HISTORIC AND DESIGN REVIEW COMMISSION

November 04, 2015

HDRC CASE NO: 2015-439
ADDRESS: 237 PALO BLANCO
LEGAL DESCRIPTION: NCB 6515 BLK 4 LOT W 50 FT OF 6 & W 50 FT OF E 100 FT OF 7
ZONING: R4 H
CITY COUNCIL DIST.: 3
DISTRICT: Mission Historic District
APPLICANT: Frank McKay
OWNER: Frank McKay
TYPE OF WORK: Window replacement, roof repair and Tax Certification
REQUEST:

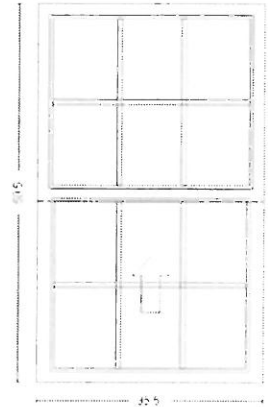
- a. The applicant installed eight (8) new one over one vinyl windows to replace eight single pane aluminum windows that were damaged in a fire. According to the Guidelines for Exterior Maintenance and Alterations, non-historic incompatible windows should be replaced with windows that are typical of the architectural style of the building. Staff finds the applicant's installation of vinyl windows inconsistent with the Guidelines, however, given the structure's existing windows were aluminum, staff finds the installation of one over one vinyl windows appropriate.

Staff recommends approval as submitted based on findings a through d with the stipulation that the applicant provide additional financial information to staff to ensure that the financial threshold for Historic Tax Certification has been met.
